## RPRC RETURN LETTER

Application Number: 2022-0602

Street Location: 5 SHIPPEN RD

Re: RPRC Return Letter, dated August 2, 2022  
5 Shippen Rd  
Application No. 2022-0602

3. PROPOSED SITE PLAN  
 SCALE: 1/16" = 1'-0"

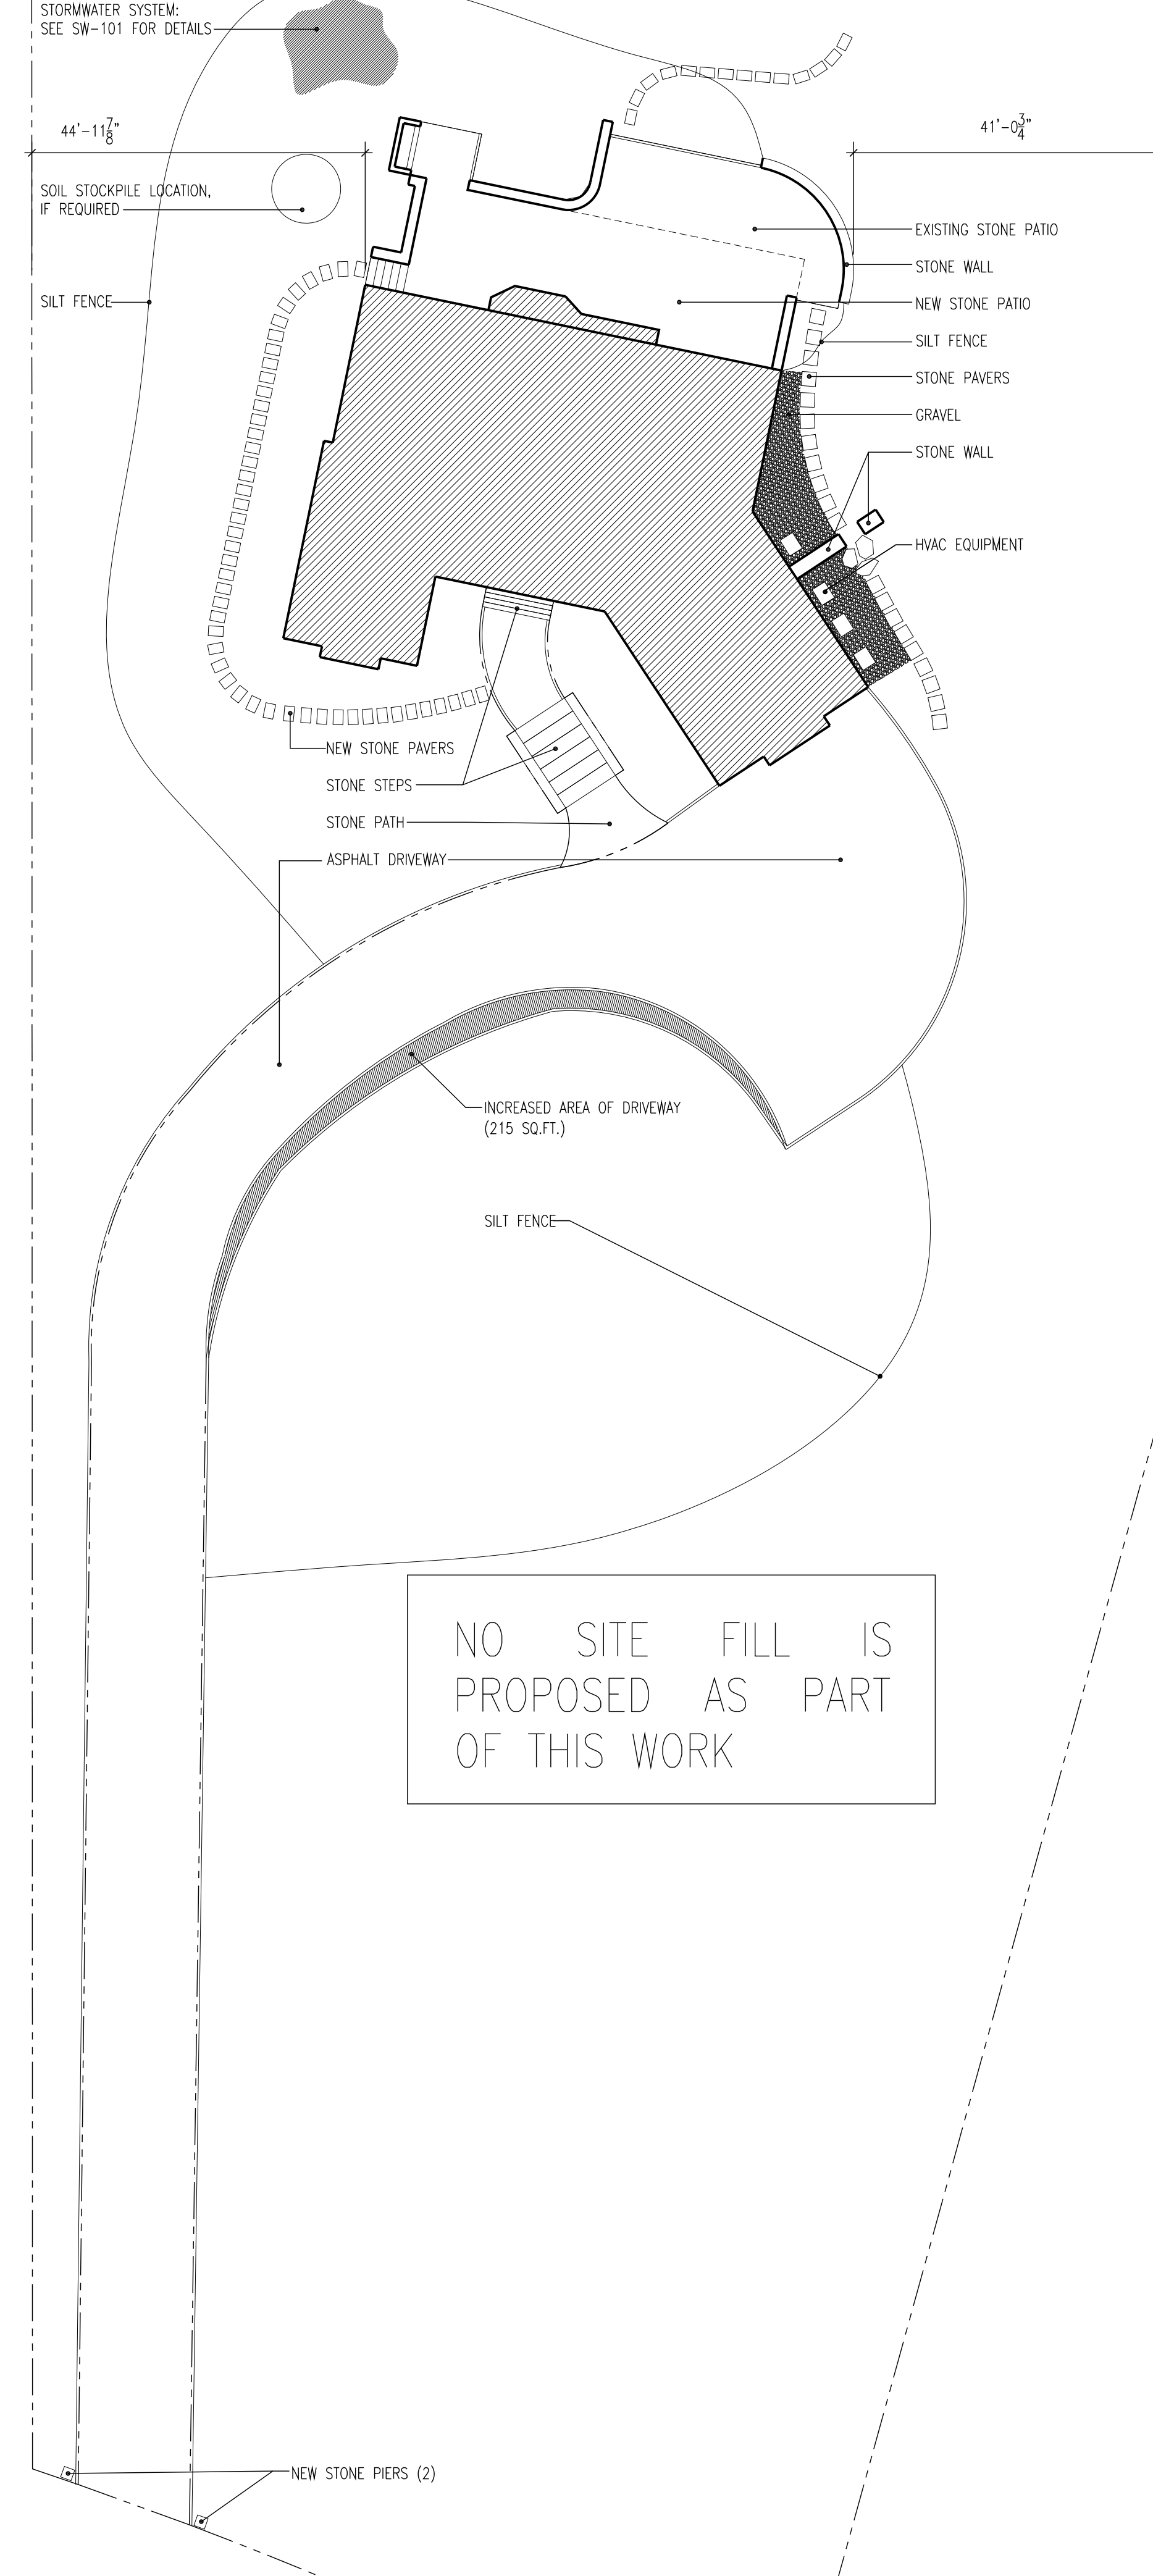
- The site plan shall be revised to contain the seal and signature of the professional preparing the plan.
- The submitted plan does not appear to be correct. The plan depicts a wooden deck at the rear of the house; however, the site contains a patio in this location. The plan shall be revised to clarify whether a deck is proposed. If a deck is not proposed, the site plan should be revised to correctly label the patio.

- The site plan contains a red rectangle. Based upon the submitted application, this appears to be the location of a proposed patio; however, the site plan should be revised to clearly indicate that a patio is proposed in this location.

- In addition, the patio appears to be larger than that depicted on the plan; the Applicant shall clearly depict the extent of the patio on the plans. Furthermore, it appears that slate walkways were added to both sides of the house; these walkways should be depicted on the site plan and the gross land coverage added to the worksheet and backup data.

- The existing driveway appears to be currently undergoing work. The site plan should be revised to depict what work is being done in this area. The site plan should indicate whether the driveway is being expanded. If so, the gross land coverage associated with the changes should be depicted on the GLC worksheet and backup data.

- If required by the Building Department, the site plan shall be revised to dimension the patio to adjacent property lines. Pursuant to Section 355-15.A of the Town Code, the patio can't be located closer than 5 feet to any property line.

- It appears that fill has been brought onto the site. The site plan should depict changes to topography and the amount of fill brought to the site. In addition, a fill permit may be required from the Building Department.

- Stamped and signed site plan(s) have been provided.
- Site plan has been amended to reflect actual site conditions and dimensions.
- Area of “red rectangle” has been clarified on site plans.

- Patio dimensions have been field-verified and adjusted accordingly on site plans. Walkways to the East and North of the house were in place previously and are shown on the “Existing” and “Proposed” site plans on drawing S.01. Walkway on the west side of the house is new and is shown on the “Proposed” plan only.

- Scope of work on driveway has been shown and increased area is included in the gross land coverage calculations.
- Site plan has been updated by my office, under my license, to depict existing and proposed conditions, with new work called out on drawing 3/S.01.

- Dimensions locating the patio to adjacent property lines have been added to drawing 3/S.01.
- No fill has been brought to the site. A note to this effect has been added to drawing 3/S.01.
